Re: Finance Docket No. 36284 - Seven County Infrastructure Coalition - Uinta Basin
Railway Project - Response to Information Request No. 5

**Seven County Infrastructure Coalition's Response to the
STB Office of Environmental Analysis February 24, 2020
Request for Information No. 5**

Figure 1 – Communications Tower Locations

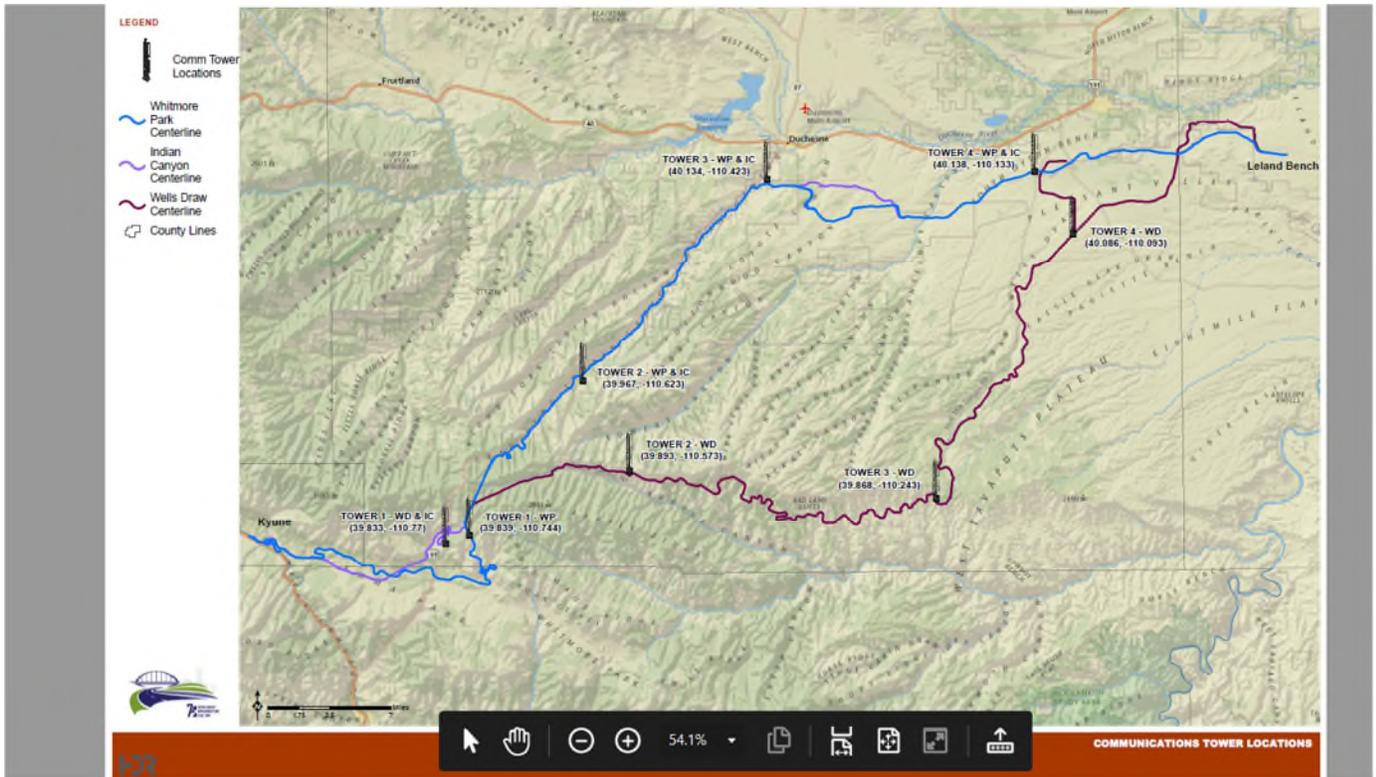
6. **OEA Request:** Please provide a corrected version of Table 1 that was submitted in response to Information Request #3. The previously submitted version of this table identifies some communications towers as being located within the proposed rail right-of-way, while the accompanying GIS data appears to show those towers as being located outside of the proposed rail right-of-way. The corrected table should provide accurate information regarding the locations of communication towers in relation to the proposed rail line.

Coalition Response: An updated version of Table 1 originally appearing in response to Information Request #3 is provided below. Some of the communications towers are anticipated to be located outside of the proposed right-of-way, as shown in Table 1 below.

Figure 1 below identifies the correct communications tower locations, which are also reflected in the GIS data uploaded to the UBRY project SharePoint site on March 9, 2020.

Figure 2 – Tunneling Construction

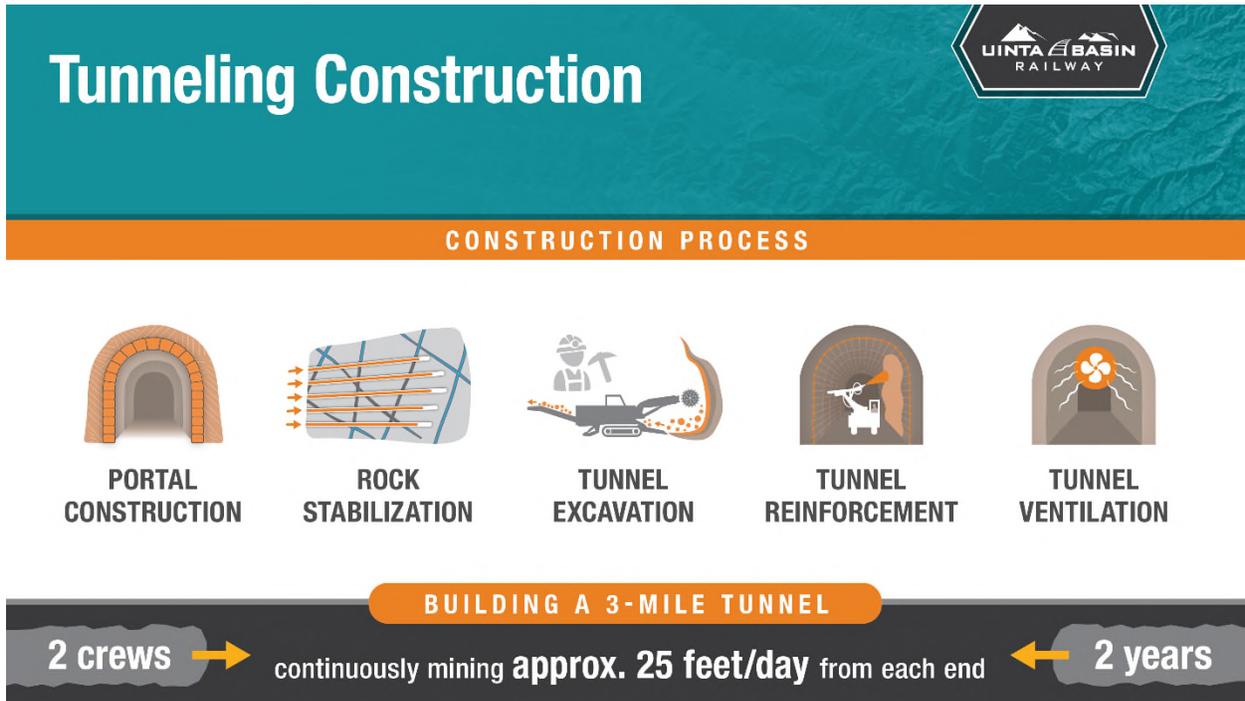
9. **OEA Request:** Please describe the method of tunnel construction that would be used to construct each of the proposed tunnels for each alternative.

Coalition Response: In general, the Coalition anticipates using a “mined” type method of tunnel construction for each tunnel location. However, drill and blast construction may be required for certain portions of tunnel construction, depending on the length and geological features of each tunnel location. It is anticipated that drill and blast construction may be necessary if sections of very strong rock are encountered.

Figure 2 below identifies proposed construction process for the 3-mile-long tunnel located near milepost 26 on each alignment. Tunnels up to 1 mile long may not require rock stabilization, depending on the geologic features encountered. Tunnels up to 1 mile long will not require ventilation.
